PIC16(L)F1782/1783 Family Silicon Errata and Data Sheet Clarification

The PIC16(L)F1782/1783 family devices that you have received conform functionally to the current Device Data Sheet (DS41579C), except for the anomalies described in this document.

**FIGURE 1: ADC 12-BIT MODE, SINGLE-ENDED INL, VDD = 3.0V, TAD = 4 us, 25°C,
TYPICAL MEASURED VALUES**

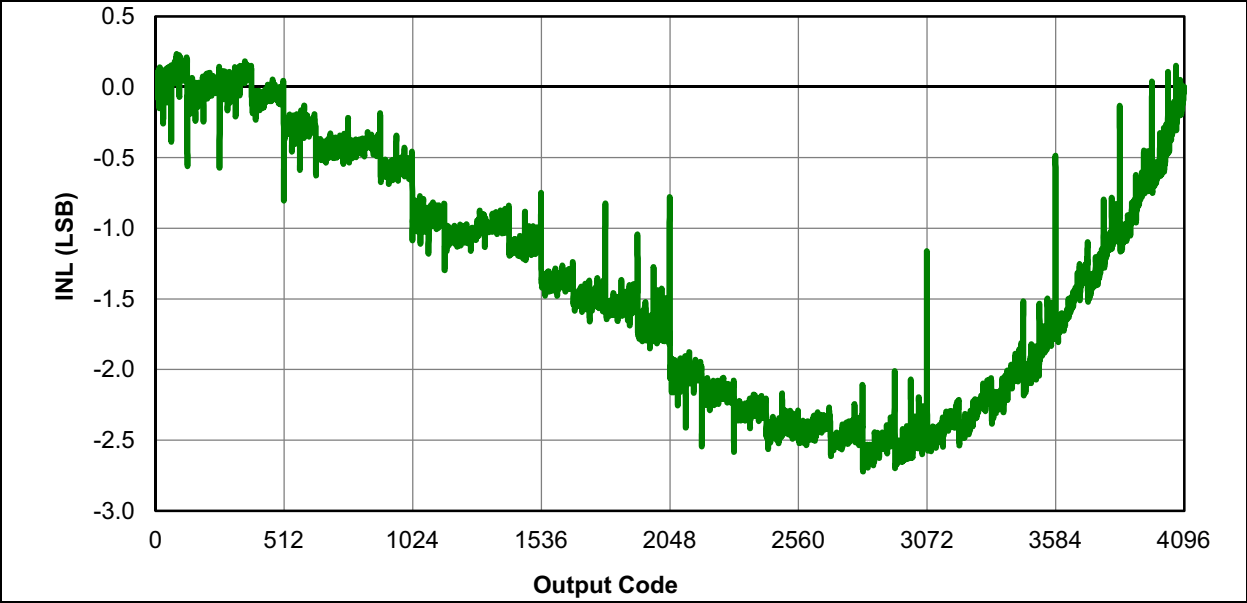
The ADC linearity is ± 4 LSb for the 12-bit mode.
Below are typical INL graphs in 12-bit mode (See [Figure 1](#) and [Figure 2](#)).

None.

**FIGURE 3: OP AMP TYPICAL OFFSET VOLTAGE AT 25°C,
HIGH GBWP MODE (OPA_xSP = 1), V_{DD} = 3.6V, 0V ≤ CMV ≤ 5.5V**

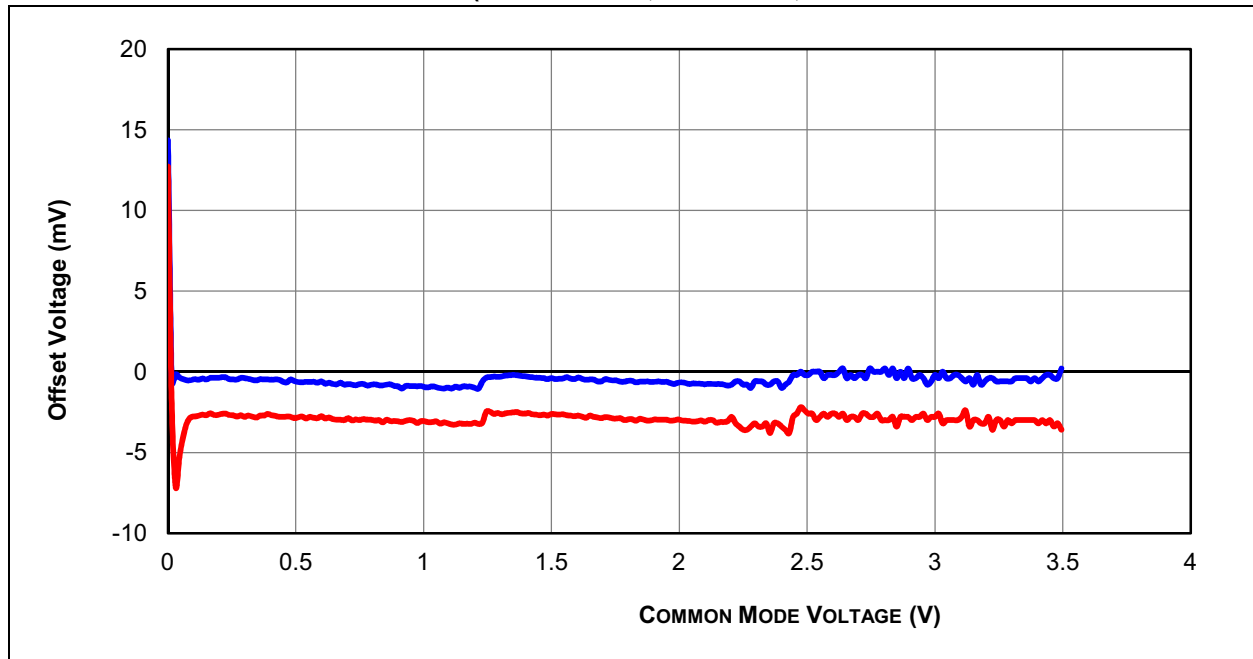
The op amp offset at Common mode input voltages below 200 mV increases with respect to temperature. Below are typical graphs showing the increase in offset (See [Figure 3](#), [Figure 4](#) and [Figure 5](#)).

None.

FIGURE 6: COMPARATOR INPUT OFFSET, TYPICAL MEASURED VALUES, NORMAL SPEED MODE ($CxSP = 1$), $V_{DD} = 5.5V$, PIC16F1782/1783 ONLY

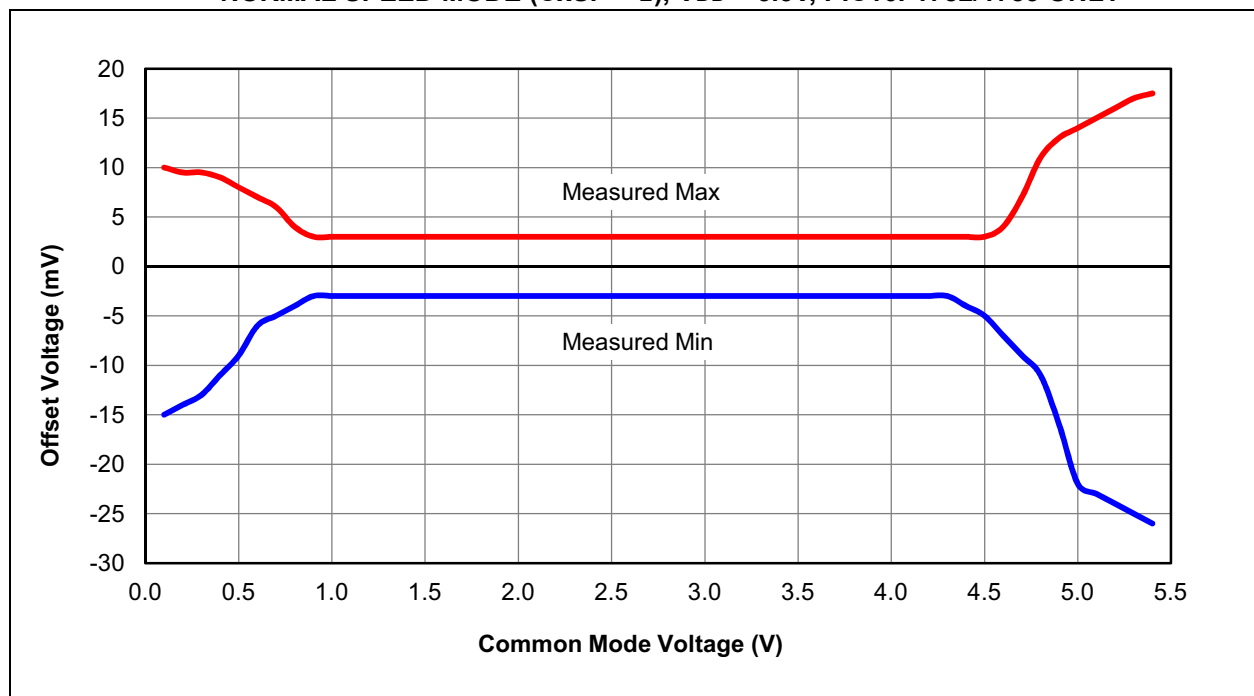
CMRR performance for the range of $V_{SS} + 1V$ to $V_{DD} - 1V$ is better than specified in the data sheet.

See [Figure 6](#) and [Figure 7](#).
